PZ&B Staff Combination Memorandum: Landmarks Preservation Commission and Town Council

SUBJECT: ZON-24-0077 (COA-24-028) 284 MONTEREY RD (COMBO)

MEETING: JANUARY 22, 2025, LPC
FEBRUARY 12, 2025, TC

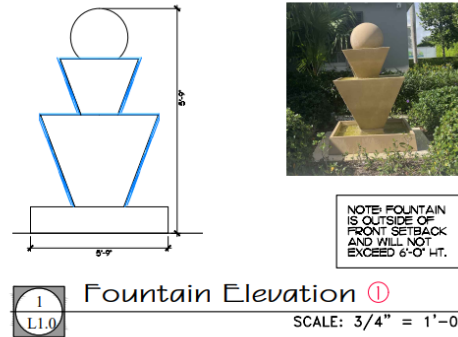
The plans show a site wall which is located within the intersection safe sight triangle for Monterey Road onto North Lake Way. Due to the substantial improvements completed at the property, the Public Works Department has determined that the site wall must comply with current intersection safe-sight triangle requirements. To reach compliance, the site wall could be relocated outside of the intersection safe-sight triangle area or lowered within its existing location to not exceed a height of 30 inches. A combination of both approaches could be considered. If the applicant wishes to maintain the wall as constructed, a relief request must be reviewed and approved by Town Council. Public Works has denied the request for the restored wall to remain. Staff has asked the applicant to present as-built drawings and photographs at the LPC hearing. Alternative designs that comply with safe-sight triangle requirements can also be presented.

The current water feature is not consistent architecturally with the house and is very visible. The applicant should return to a square basin design or eliminate the water feature entirely. The hardscape changes around the pool and landscape revisions appear to be minor.

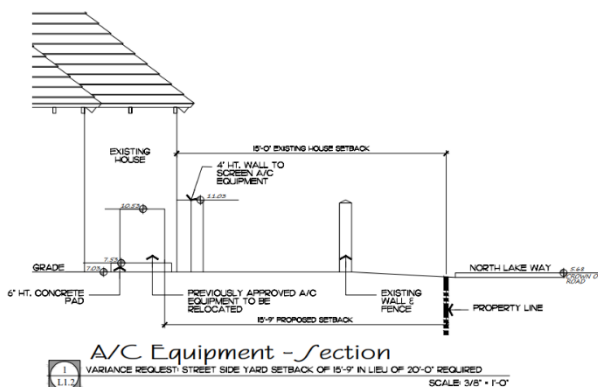
A street side yard setback variance will be required for the relocation of air conditioning equipment to the west side of the property, fronting North Lake Way. The street side yard setback will be reduced to 15'-9", in lieu of the minimum 20'-0", as summarized in the table below:

Since the applicant has not demonstrated a hardship and there is sufficient space within the property to locate air conditioning mechanical equipment outside of the setbacks, staff cannot be supportive of the variance request.
